### Addendum No. M-04

Reference: Added Scope and clarification

Issue Date: November 18, 2024

Project: UHN TWH – SEM & Corridor (EXP Project Number MRK-23004289-A0)

① Separate Price - Basement Plan  
1 : 250

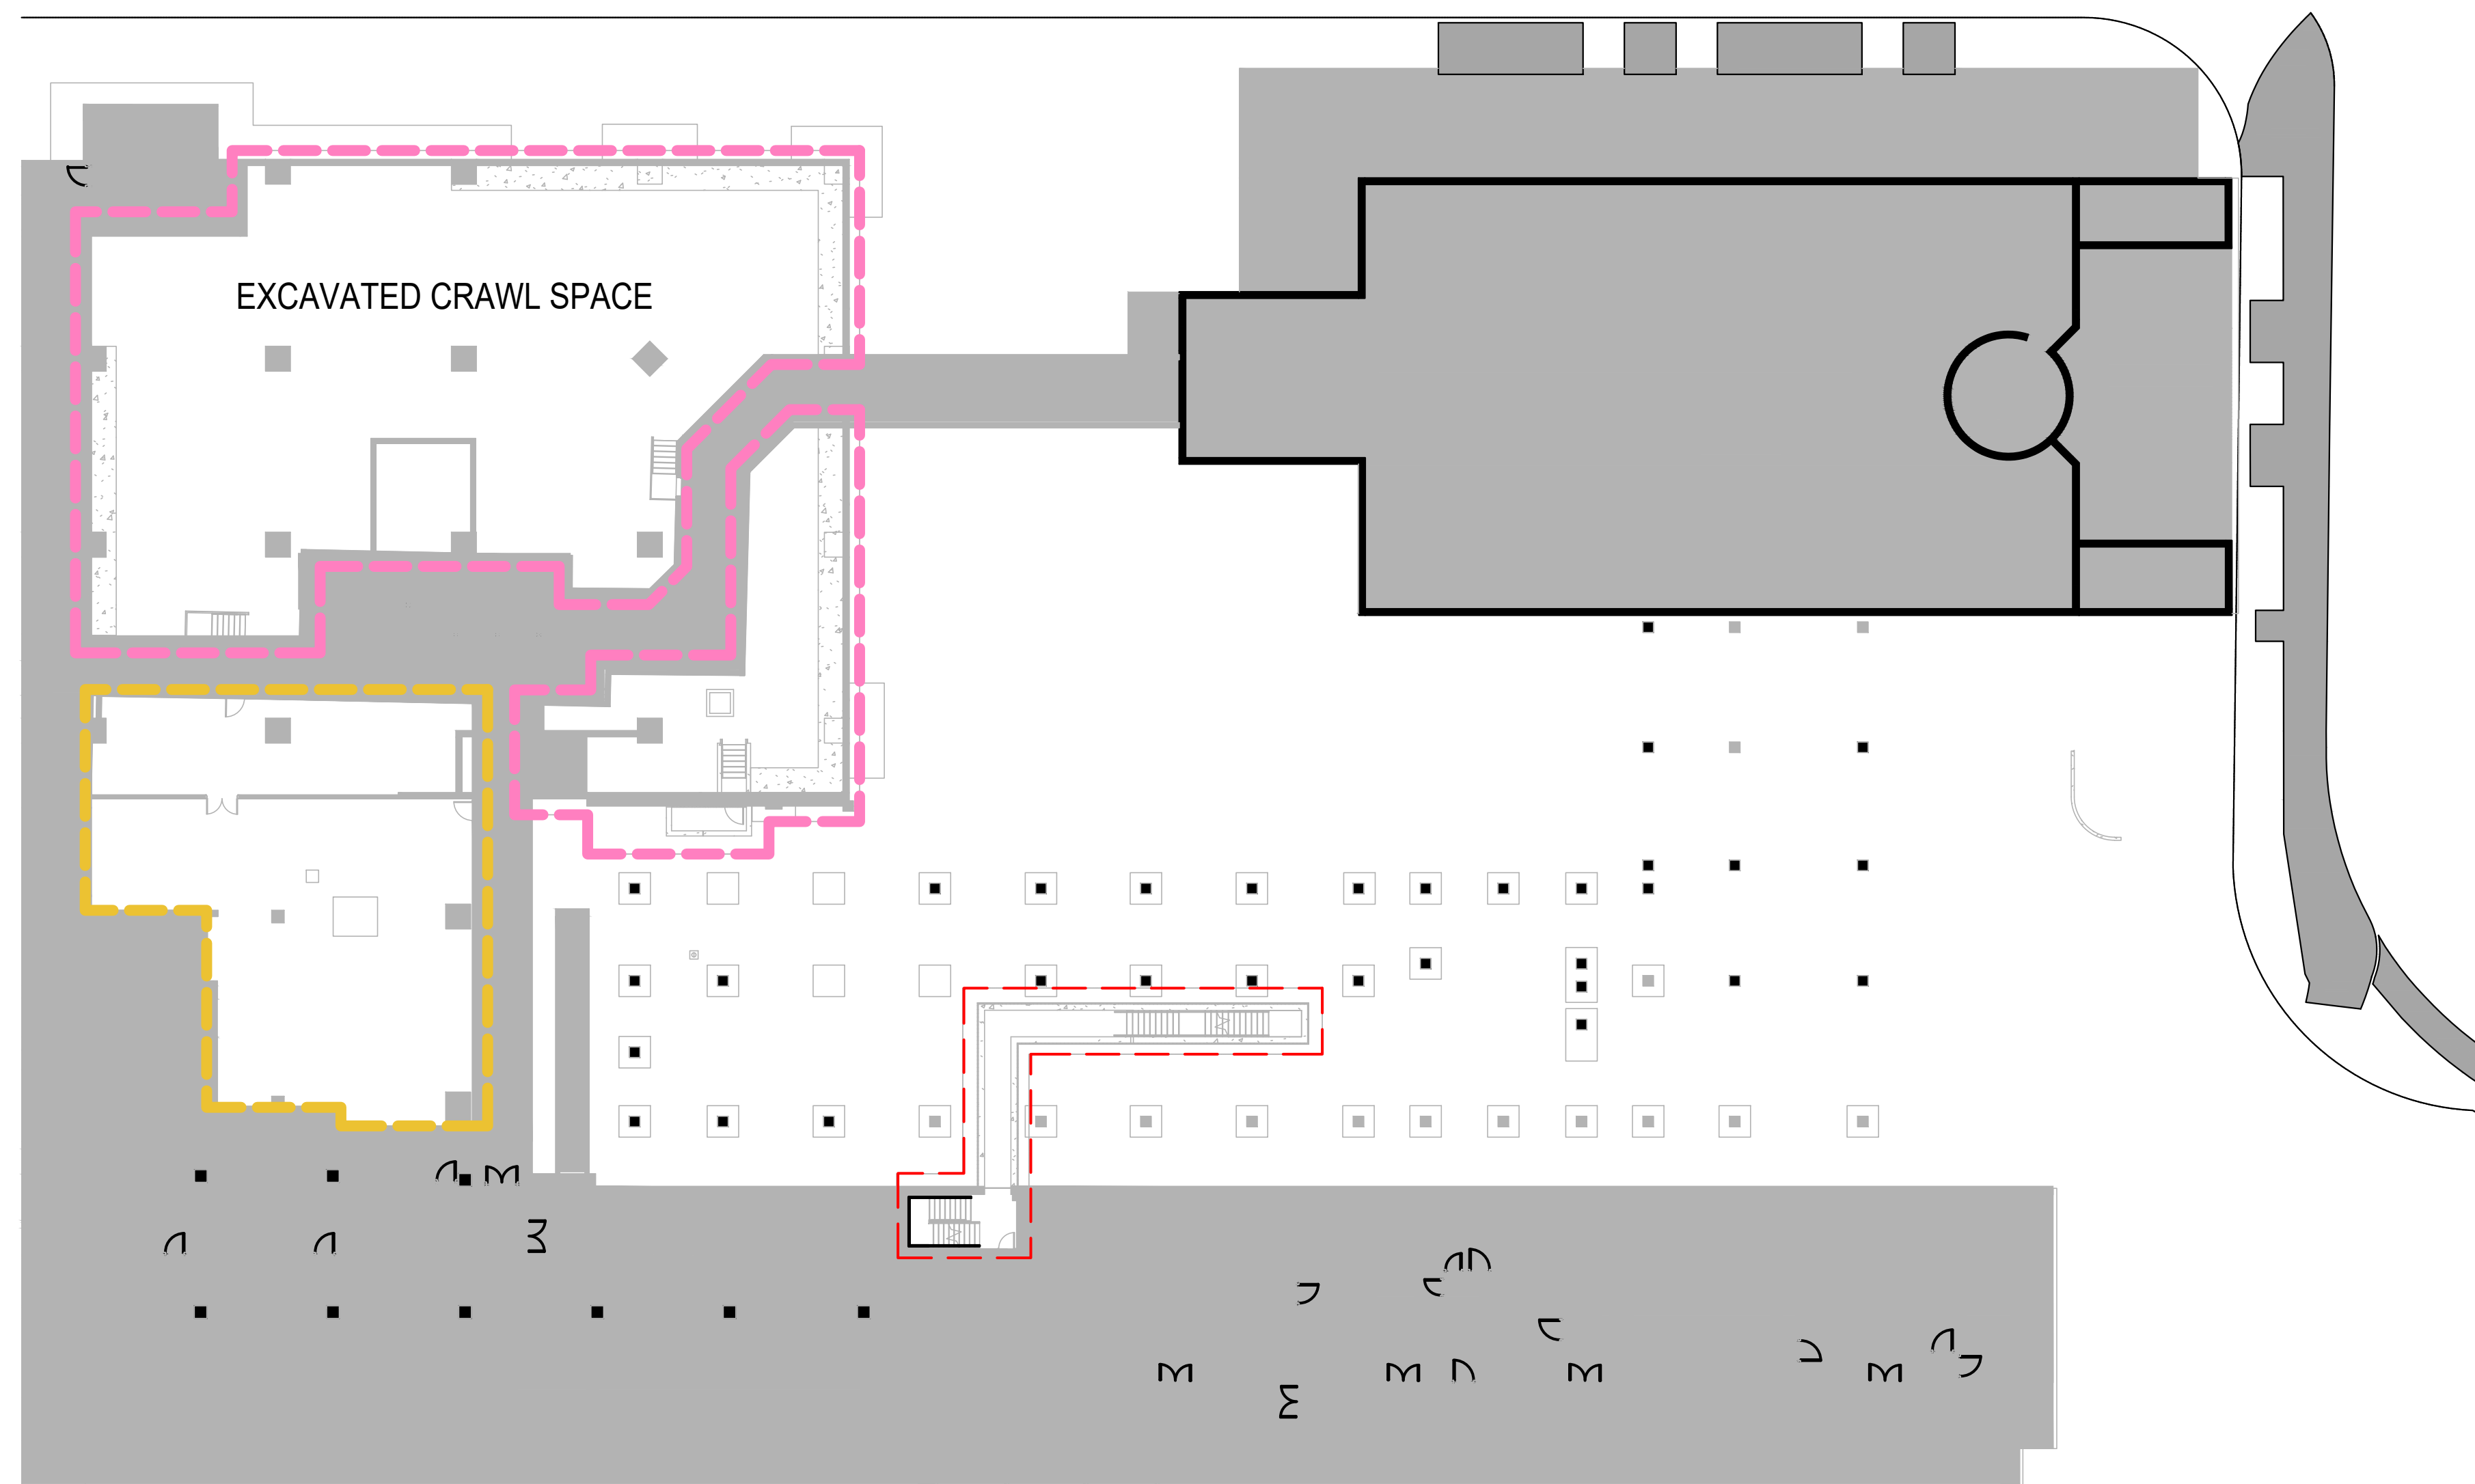
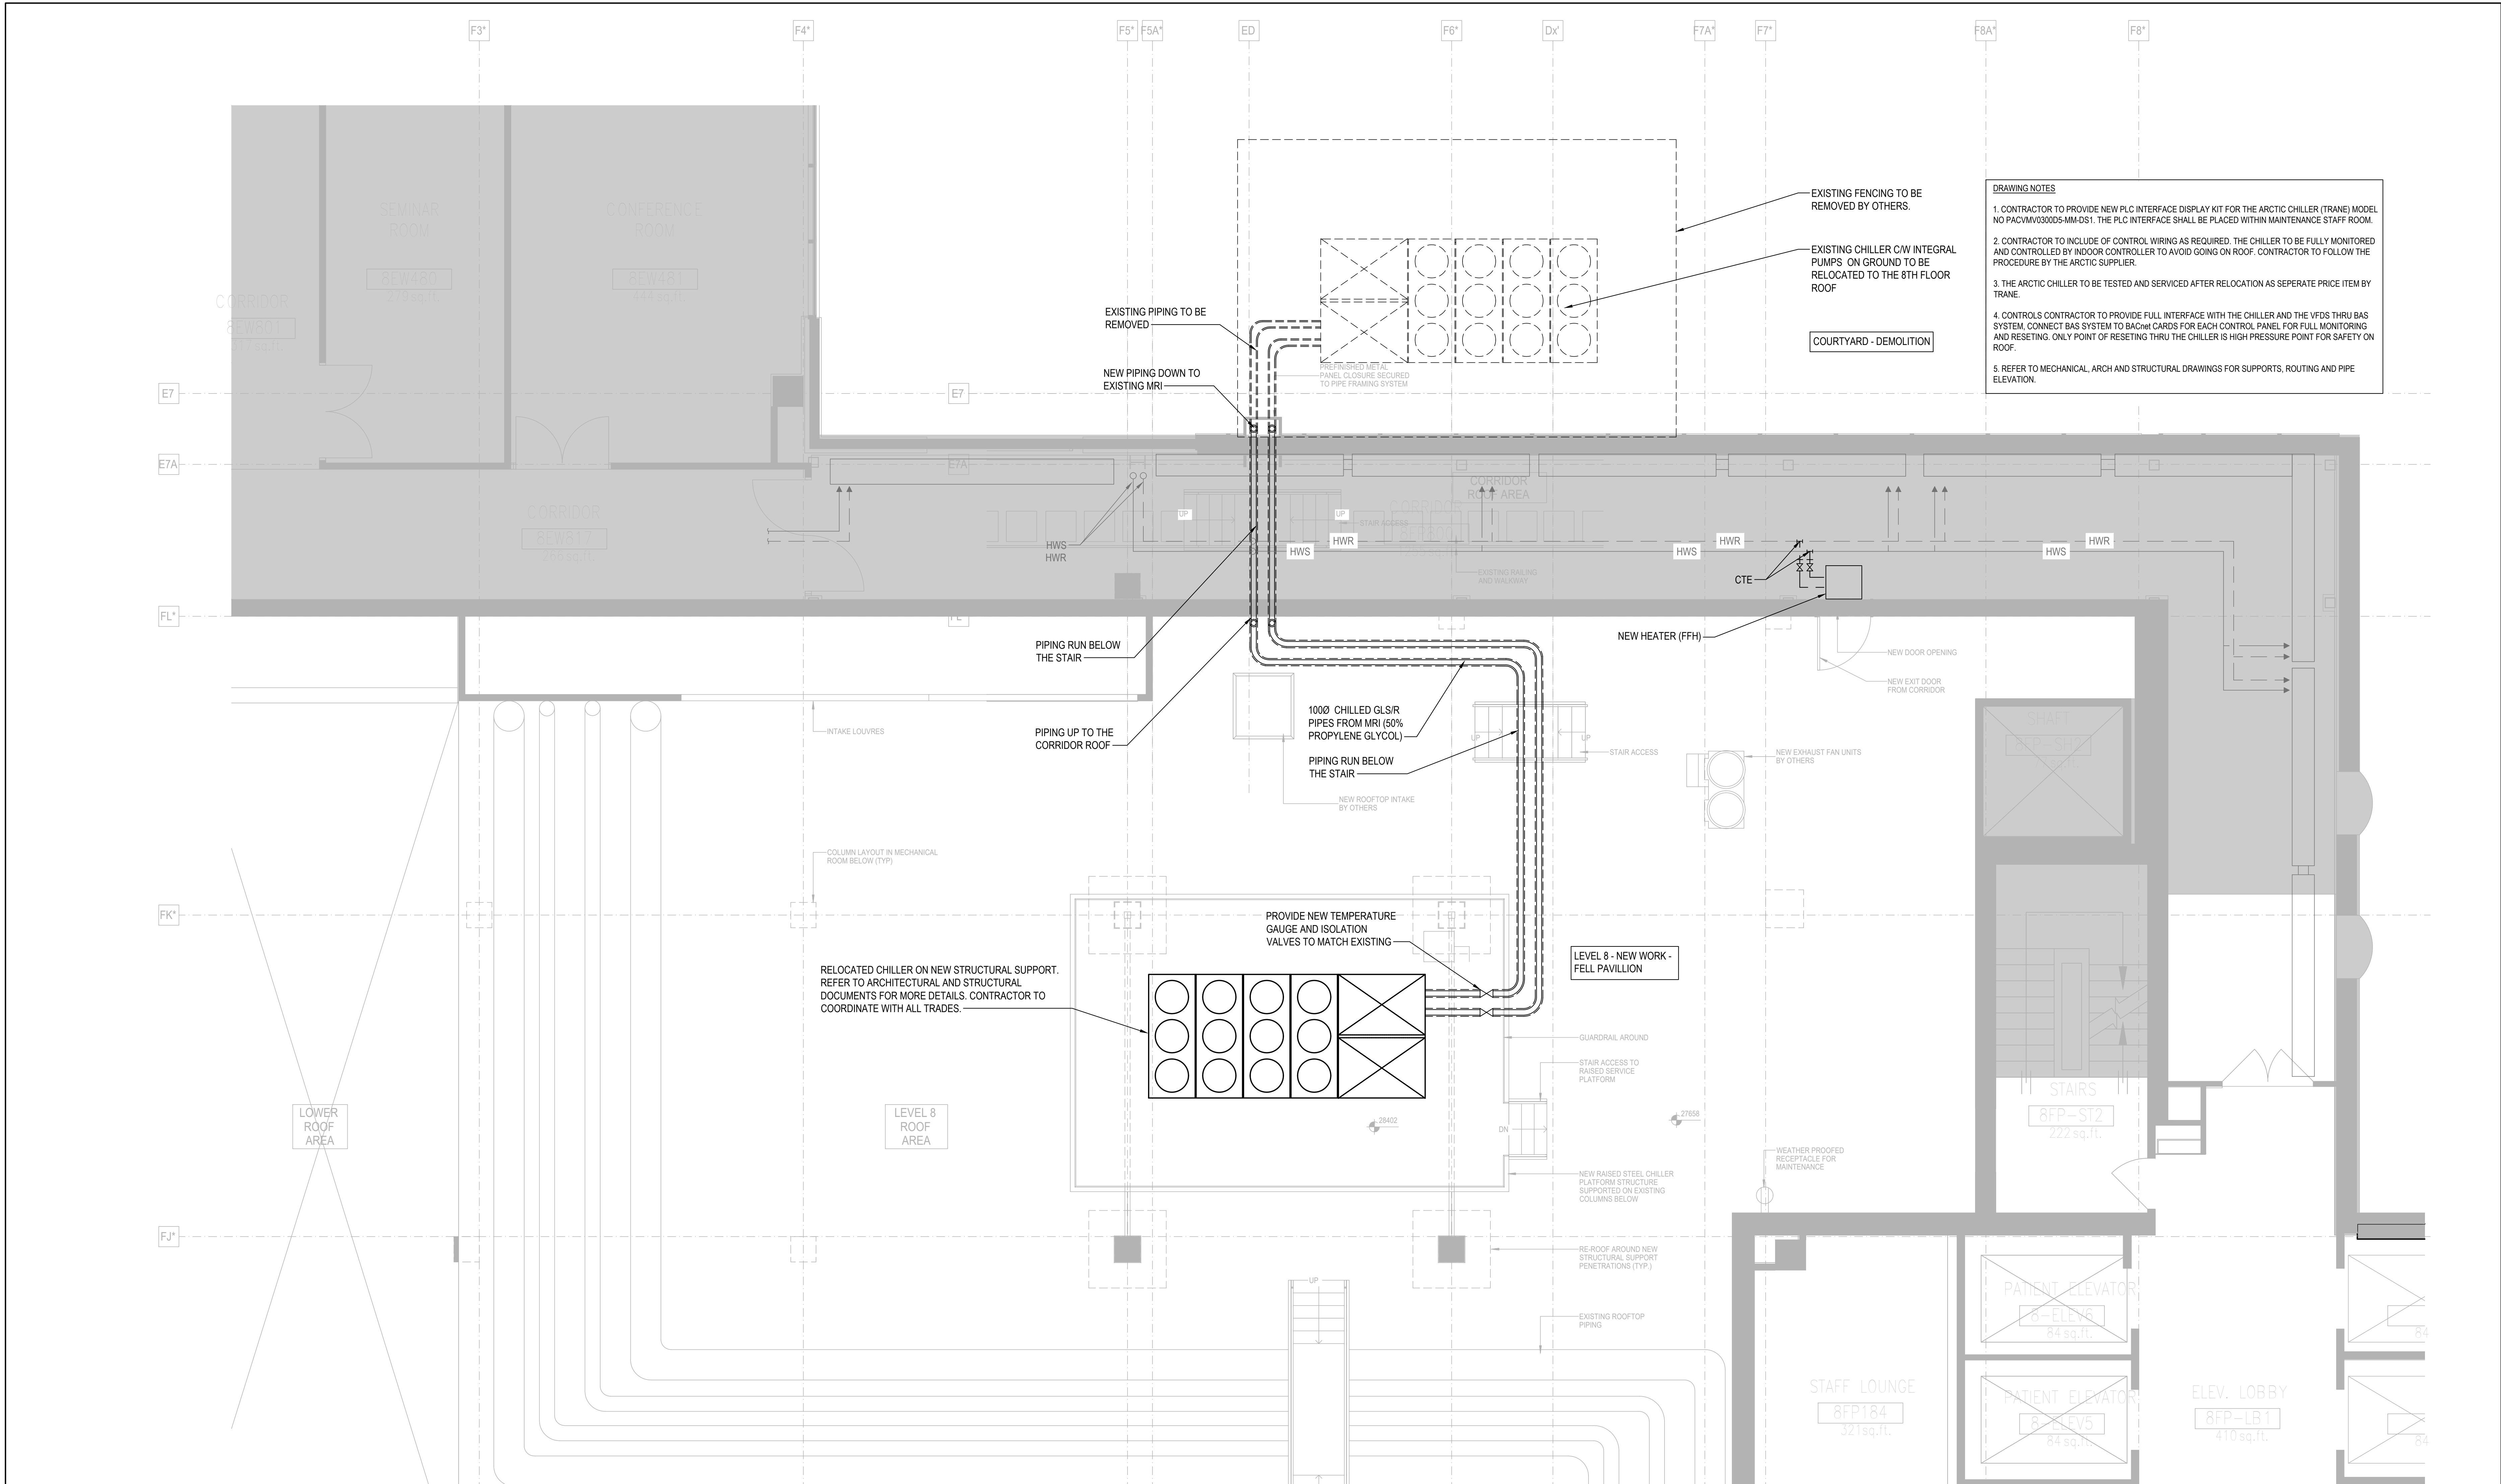
- .1 Updated the arch backgrounds.
